To: Development Review Board  
From: Mary O'Neil, AICP, Senior Planner  
Date: April 15, 2014  
RE: ZP 14-0807SP; 111 Colchester Avenue

**File:** ZP 14-0807SP

**Request:** New approximately 160,000 sq. ft. inpatient building west of the Ambulatory Care Center building at the Medical Center Campus.

SKETCH PLAN REVIEW  
INPATIENT BUILDING PROJECT

Map 4.5.2-3 ICC-FAHC Height Overlay. Location of proposed development identified.

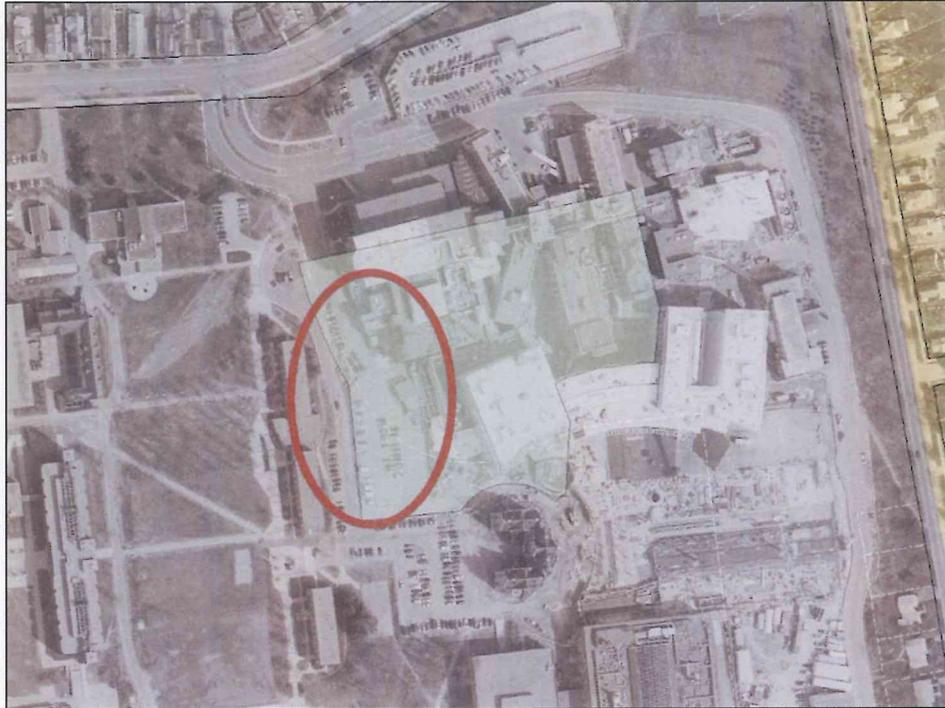
The proposed boundary line change with UVM will afford the real estate to construct the project; however portions of that Inpatient Building **will extend outside the height overlay** as defined in Map 4.5.2-3 and 4.5.2-4 of the CDO. An expansion of that height overlay will be required (with an amendment of the CDO) prior to application if the height is proposed to meet the elevation as described within this standard.

See previous comments. An amendment to the CDO to expand the height overlay to reflect the anticipated boundary line adjustment with UVM will be required to pursue this project. The applicant is alerted to begin the process to amend these allowances within the Comprehensive Development Ordinance.
